**Pendleton Office**

**Addendum #2**

Pendleton Office  
Addendum No. 2  
Date: August 11, 2025

**Date:** 08/08/25  
**Client:** SRA  
**Project:** Pendleton Park  
Hemphill, Texas  
**Project No.:** 21.095

A3 WINDOW SCHEDULE  
A403

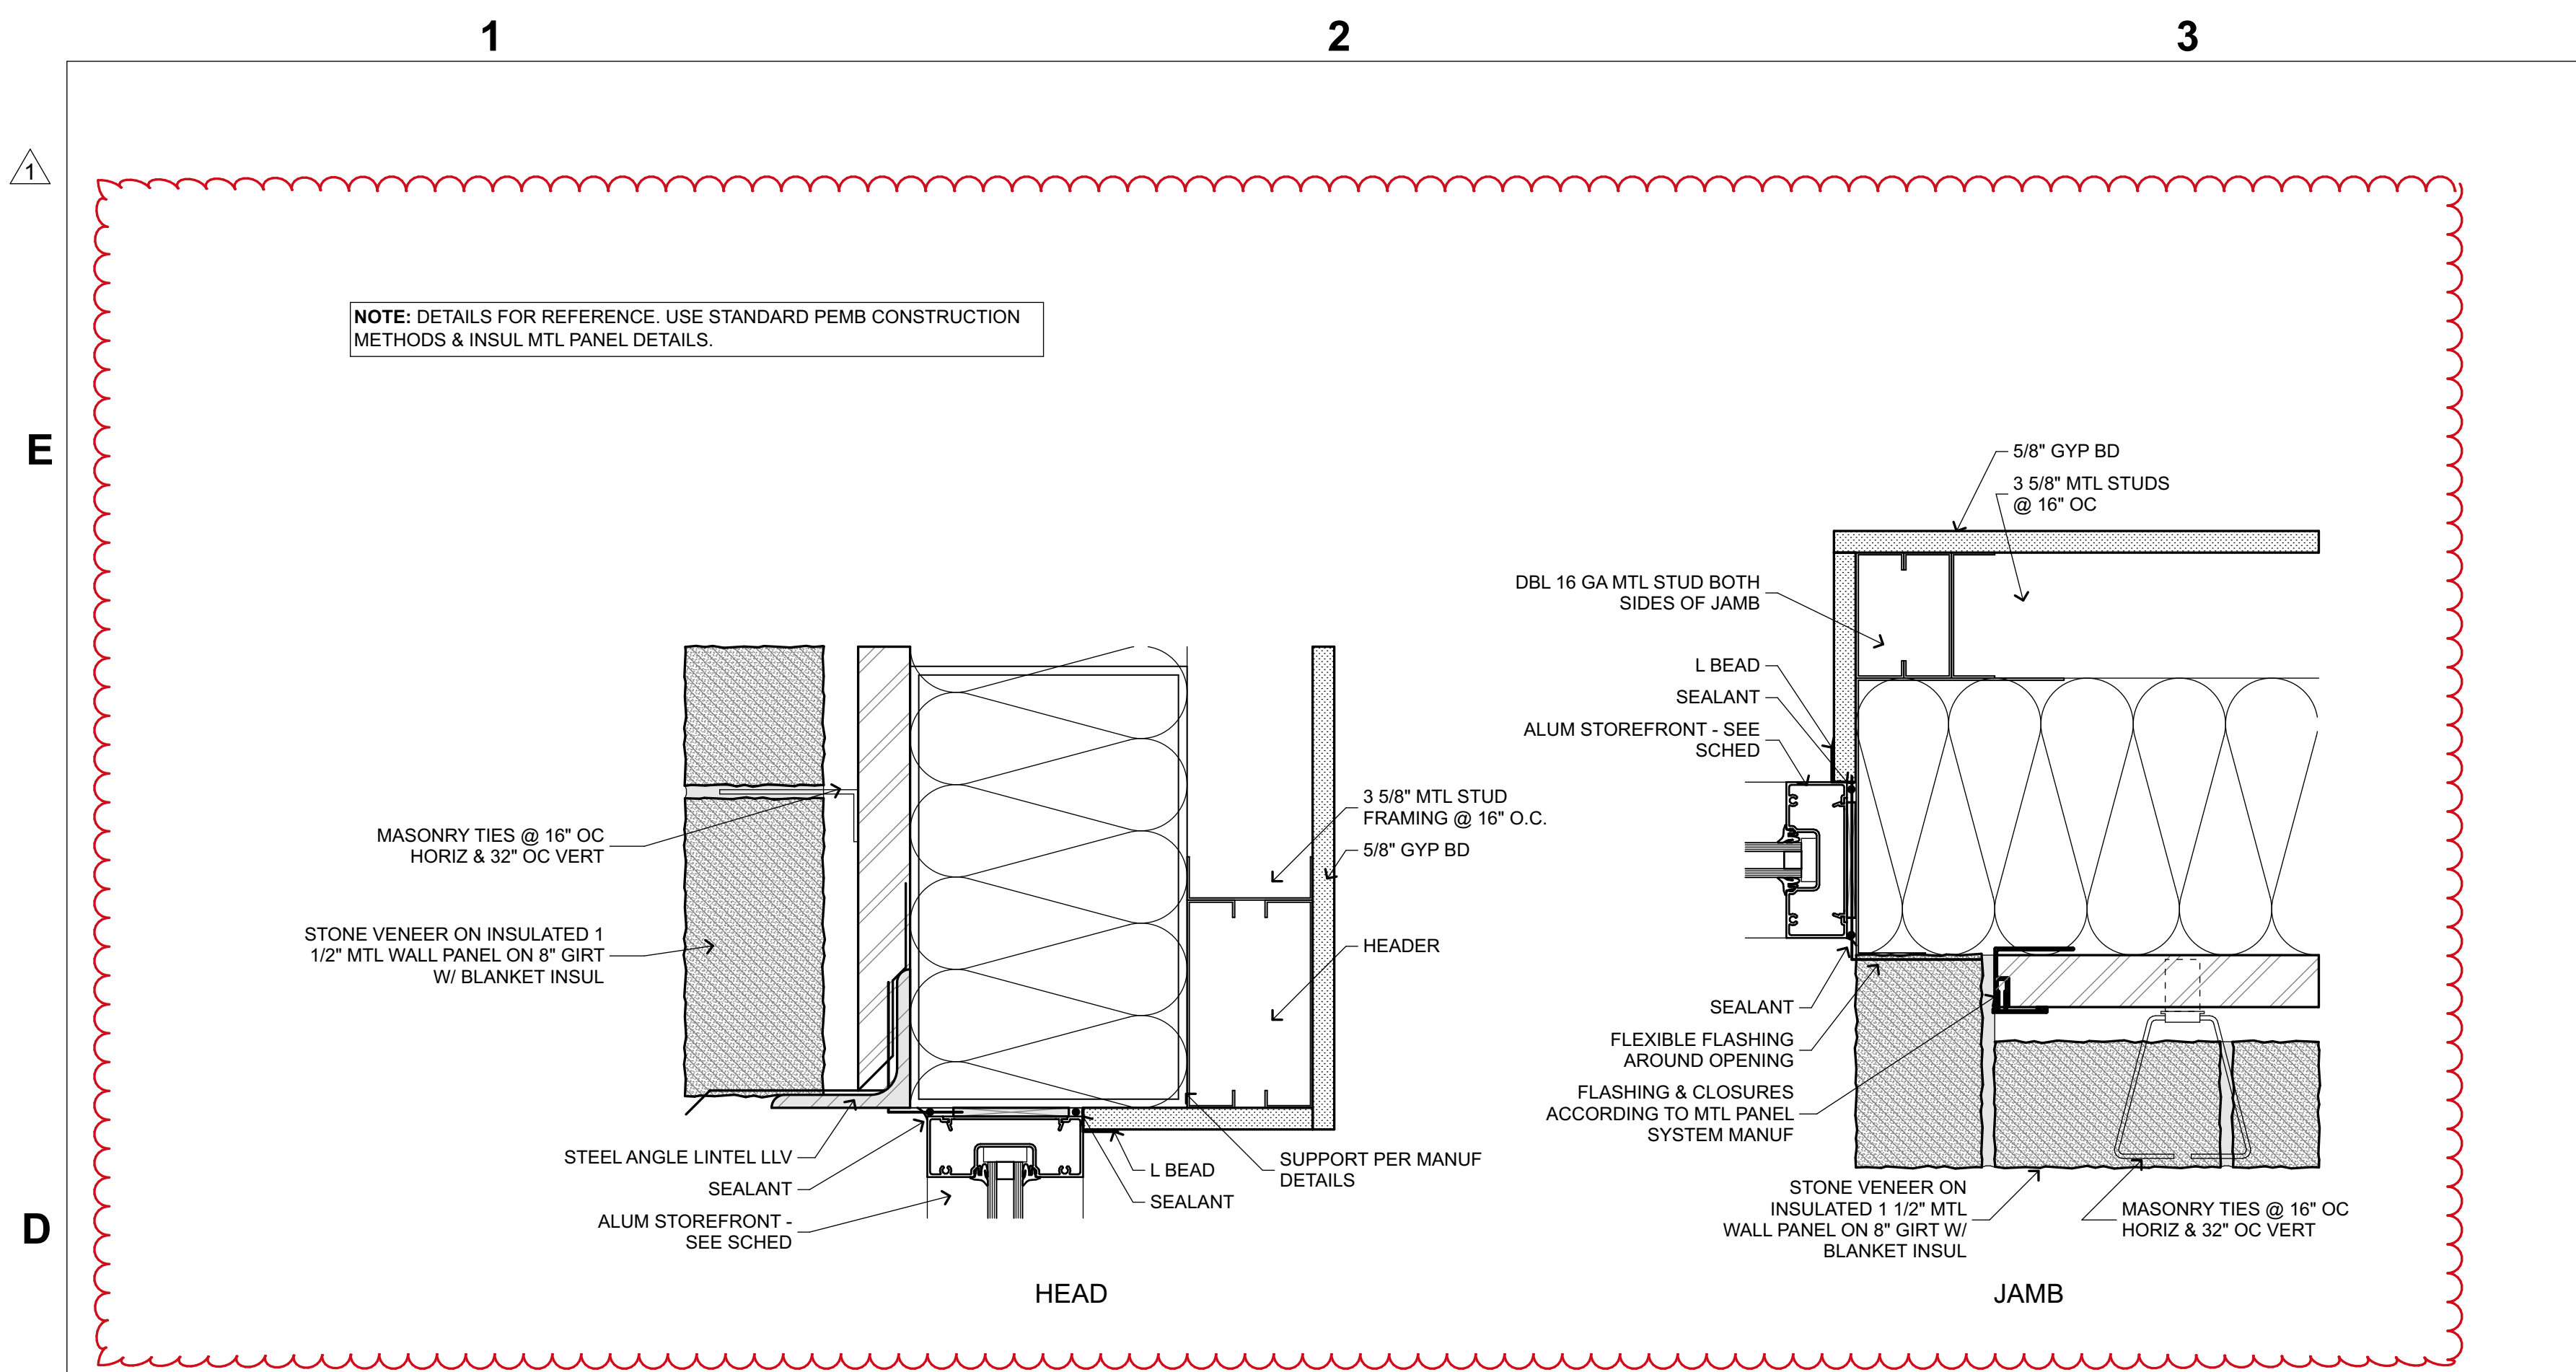
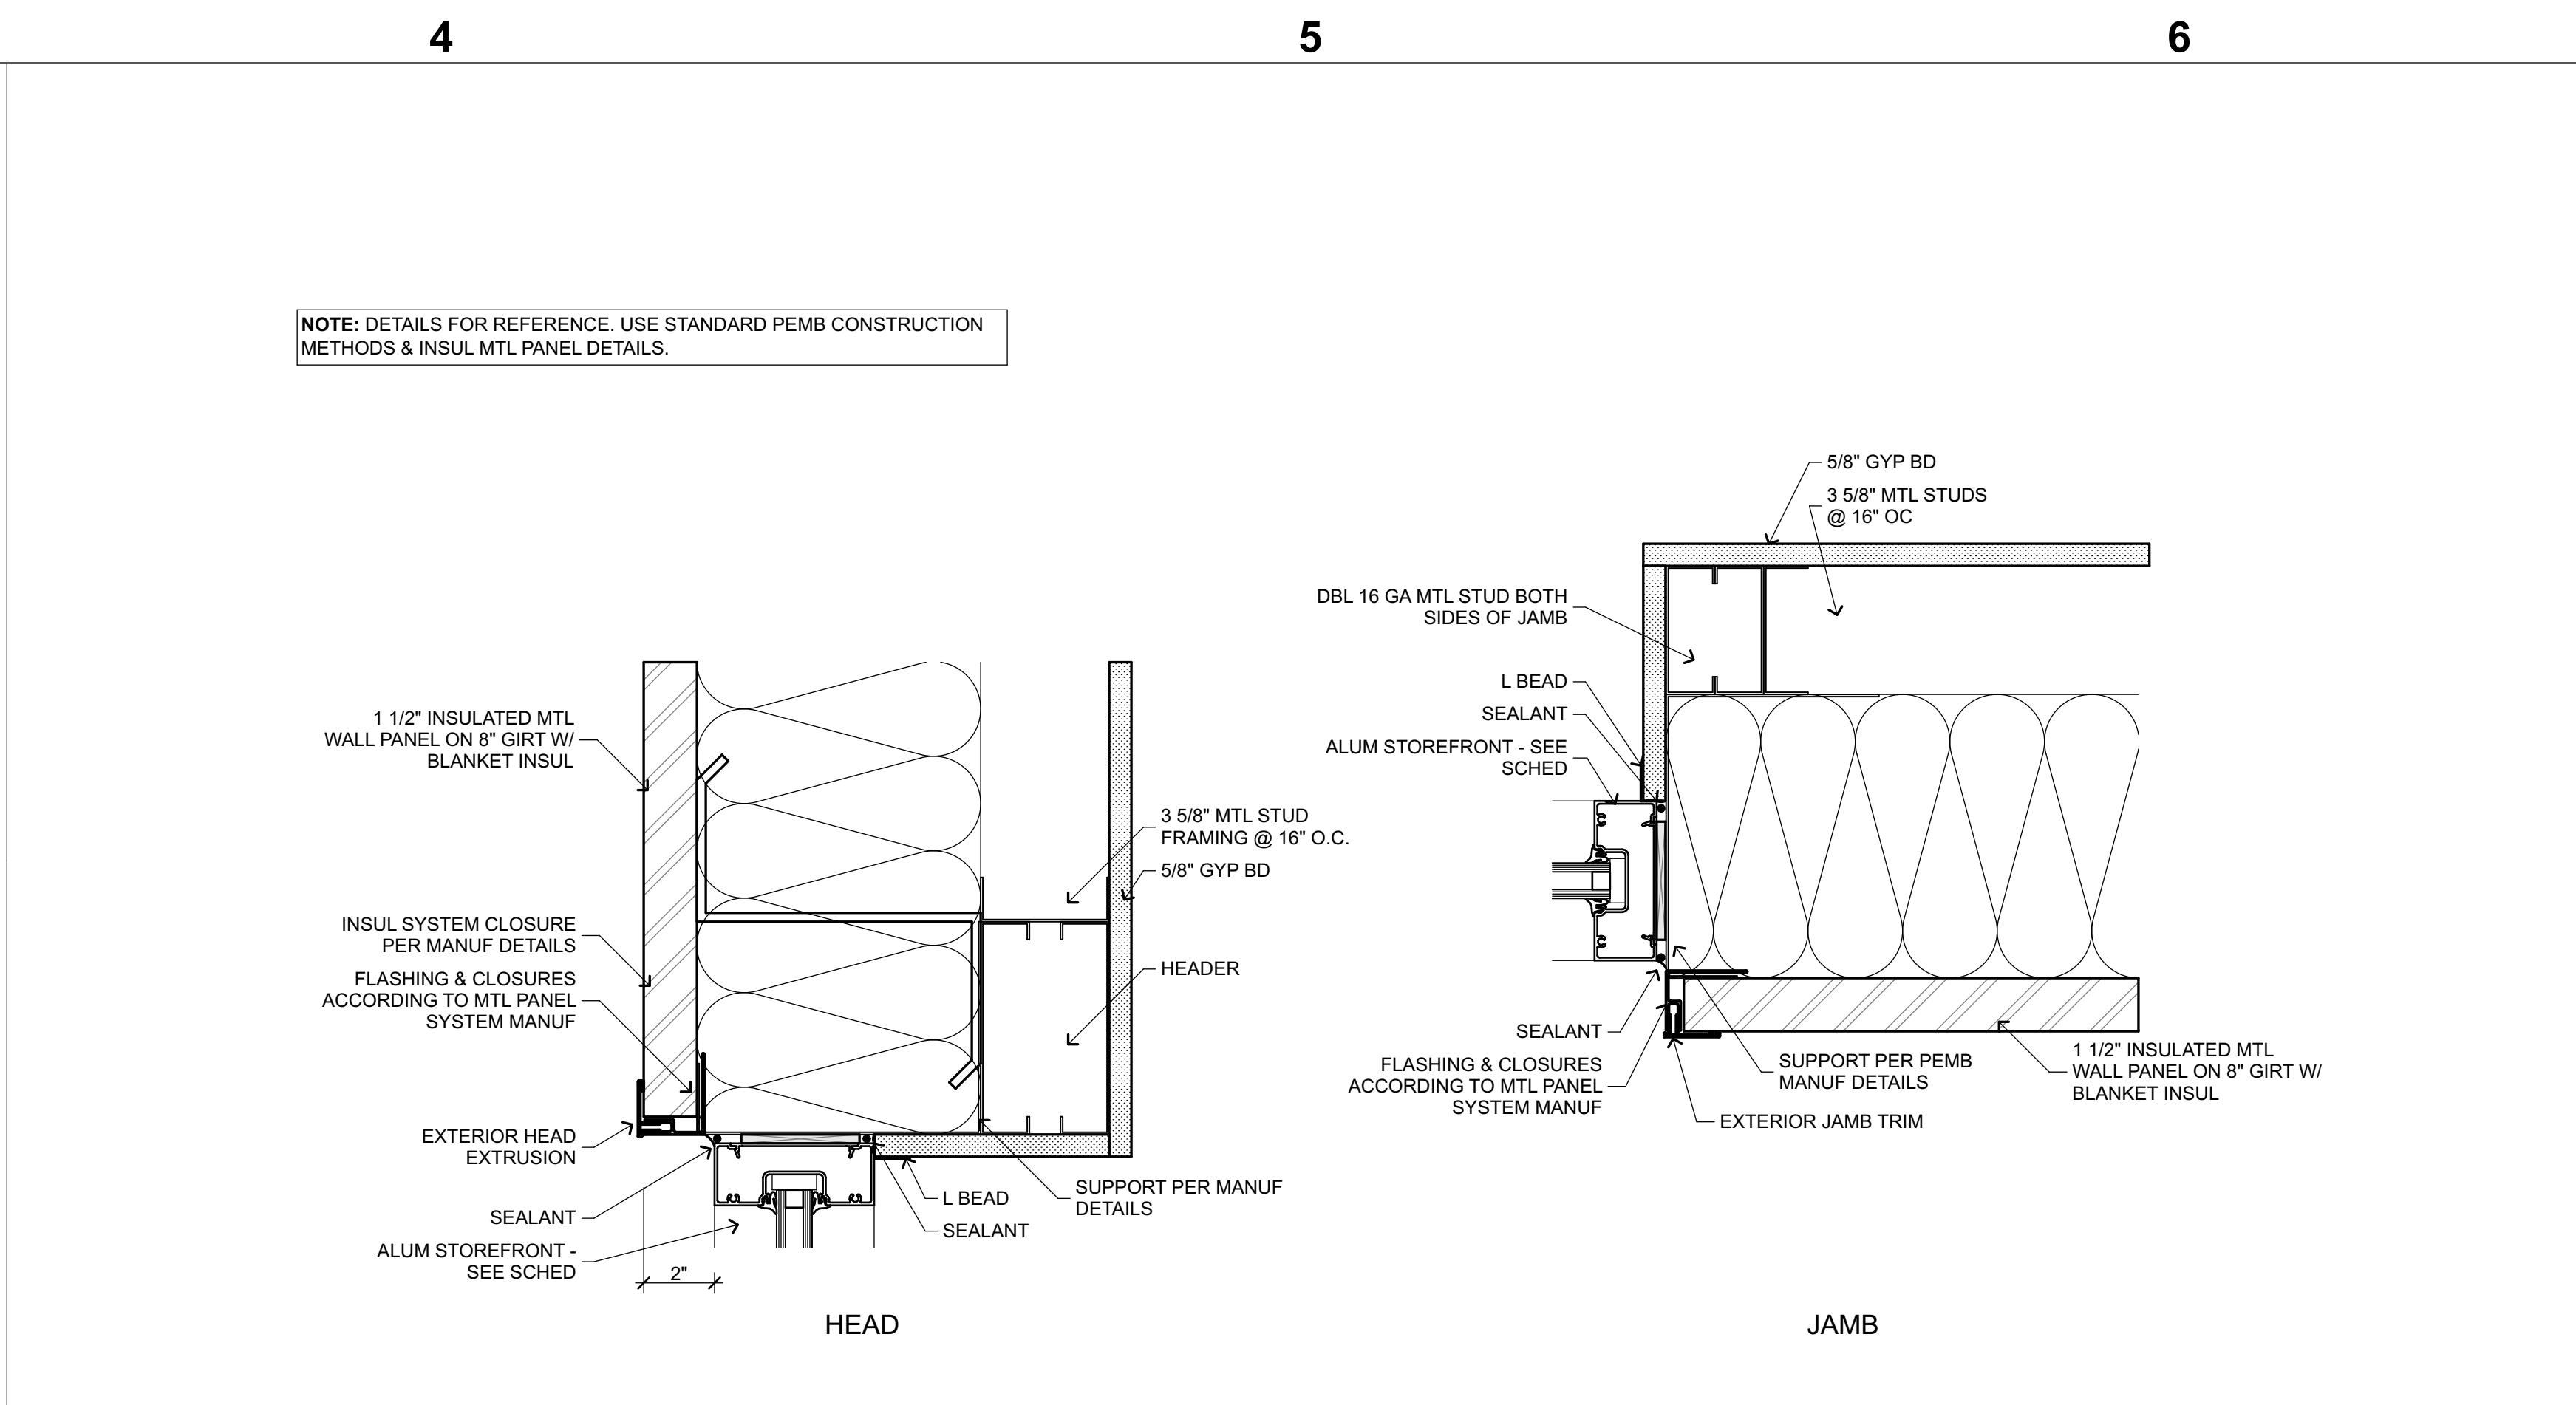
ITEM 1.06. A403 – REVISION Note added to window schedule for manual roller shade location clarification. Note added to window details for clarification. Metal panel is insulated as specified.

NOTES:  
1. HEAD/JAMB/SILL DETAILS PER PEMB MANUF  
2. MANUAL ROLLER SHADE
